# THE NEW W. EDWARD BALMER SCHOOL

## SCHOOL BUILDING COMMITTEE MEETING

MAY 8, 2019

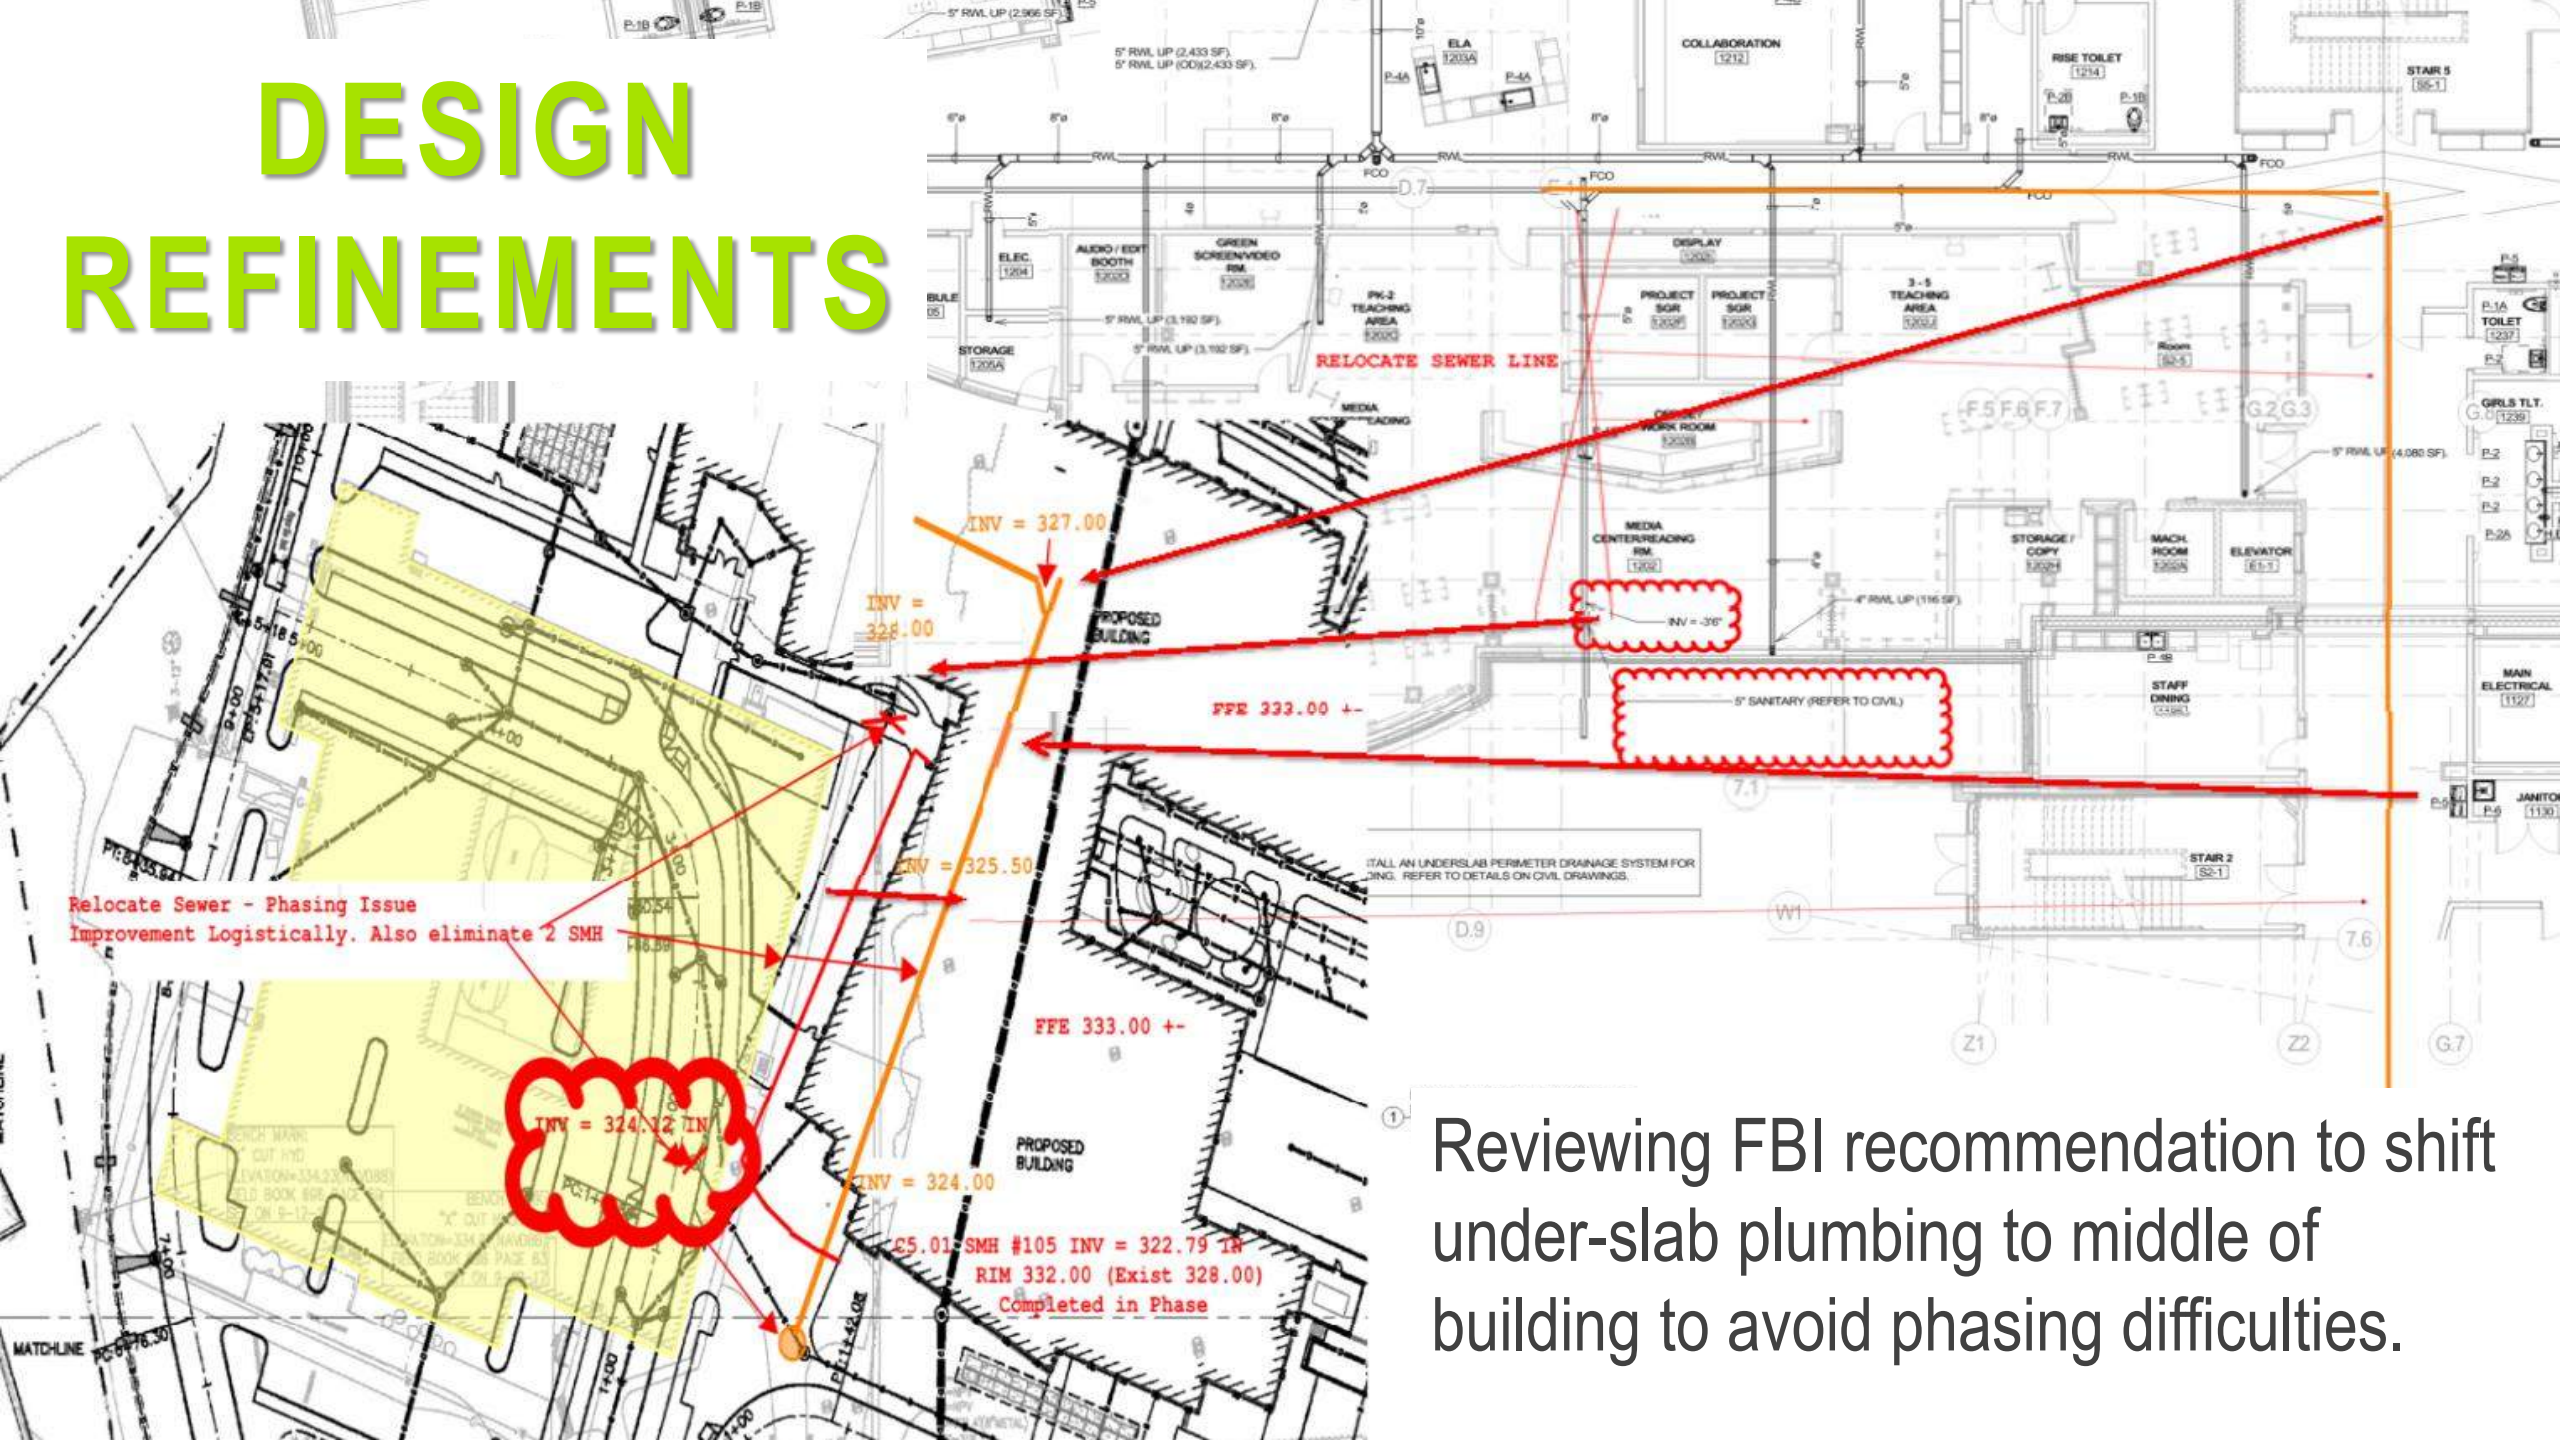
Not adopting Peer Reviewer proposed alternate alignment of 36" drain pipe under the building.

Reviewing FBI recommendation to shift under-slab plumbing to middle of building to avoid phasing difficulties.

Researching structural capacity of ductile iron pipe & soil pressure with Geotech Engineer.

Previous layout

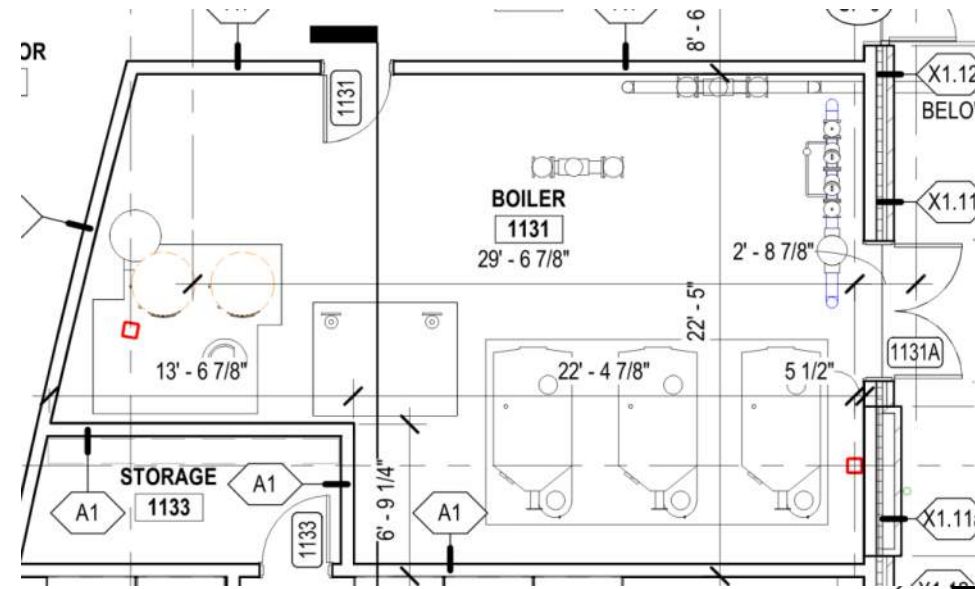
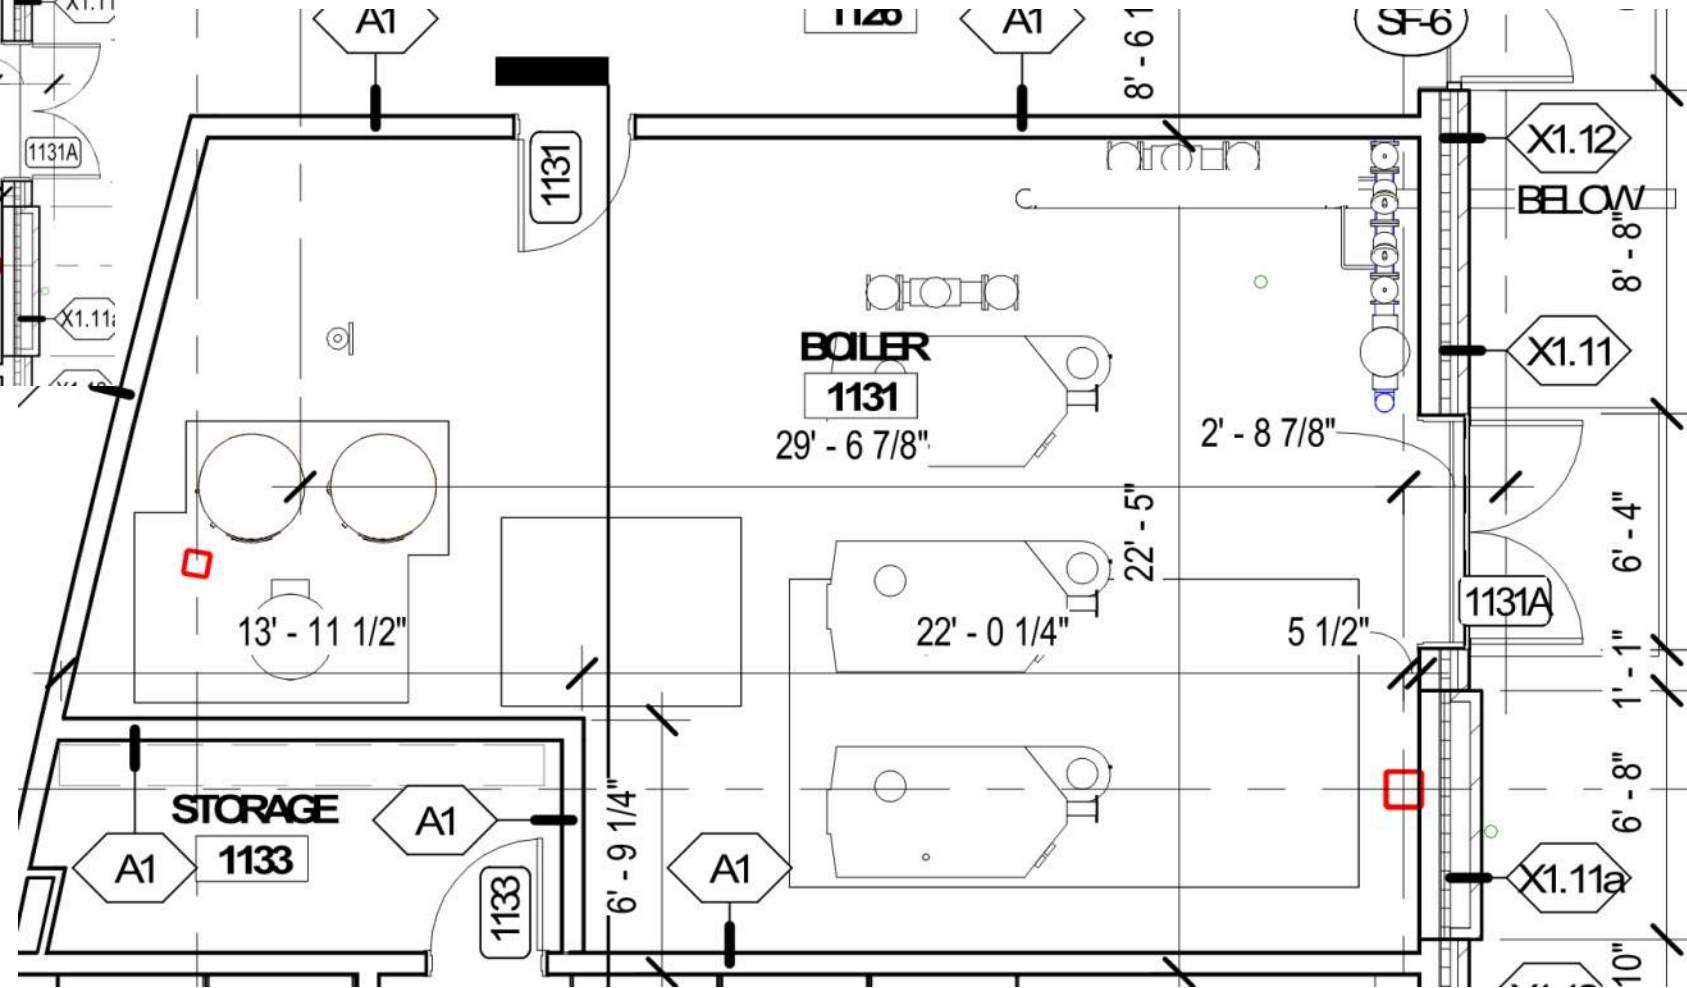
Rearranged Boiler Room to create better working clearances, clear egress doors
